Planning Commission Staff Report

Project Type: Site Development Plan

Meeting Date: February 24, 2014

Description: **Kemp Auto Museum (Chesterfield Covenant Group) SDP:** A Site Development Plan, Landscape Plan, Lighting Plan, Architectural Elevations and Architect's Statement of Design for a 0.709 acre tract of land zoned "PC" Planned Commercial District on the north side of Chesterfield Airport Rd., approximately 1,000 feet east of Chesterfield Commons Dr. (17T230189).

North Elevation

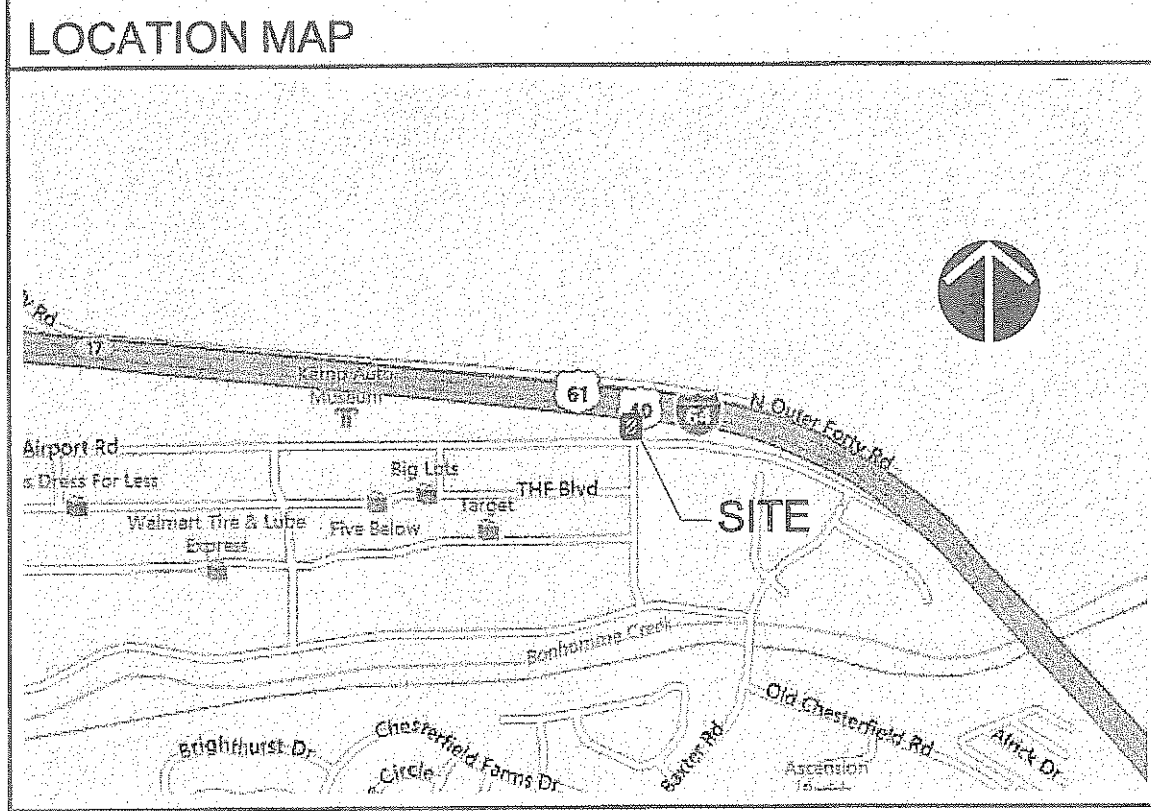
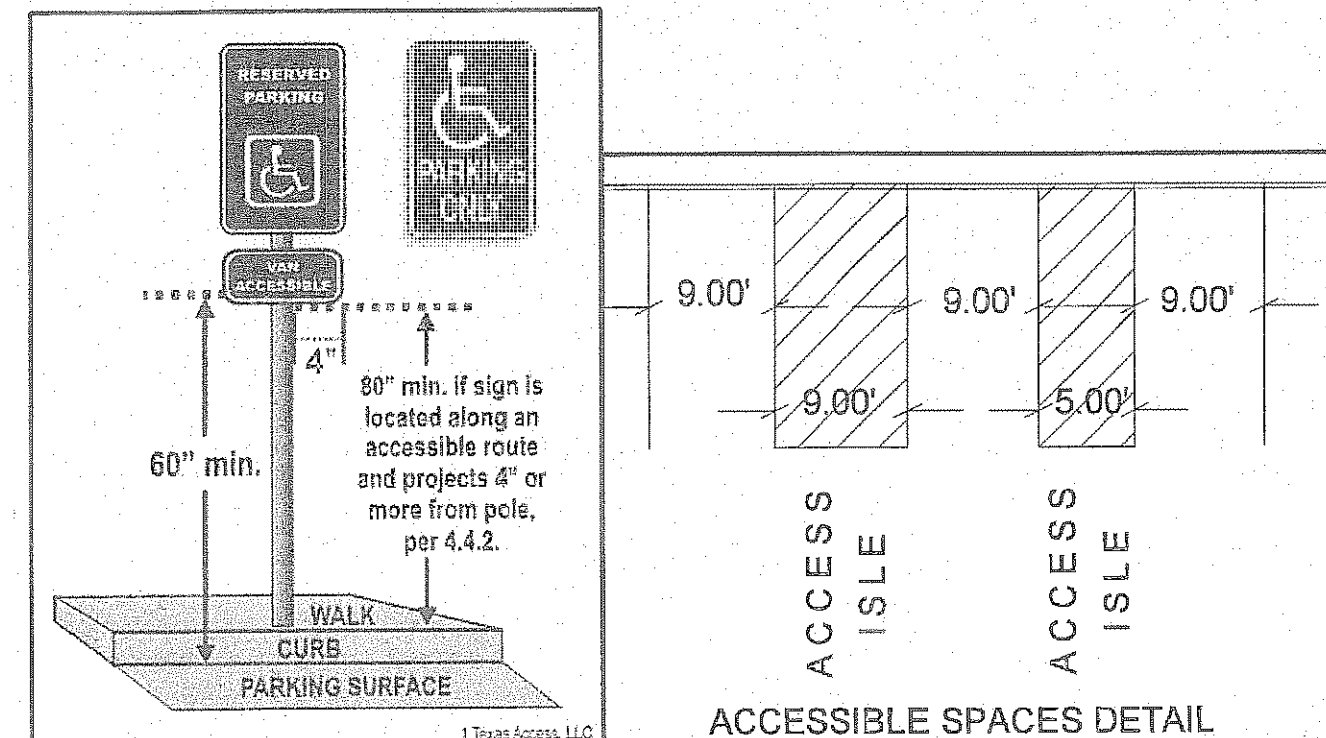
Elevations associated with this planned development were reviewed by the Architectural Review Board (ARB) on November 14, 2013. During the meeting, discussion occurred on lighting and the amount of EIFS used near ground level in lieu of additional masonry. As a result, the following recommendations from the ARB are being forwarded to the Planning Commission;

1. Add masonry wainscoting along the base of the building on all sides consistent with the height of the masonry on the columns.

2. Extend the 8"band depicted on the north elevation around the entire perimeter of the building.

Subsequent to the ARB meeting, the Applicant did amend their elevations associated with this proposal and have addressed both items listed above. .
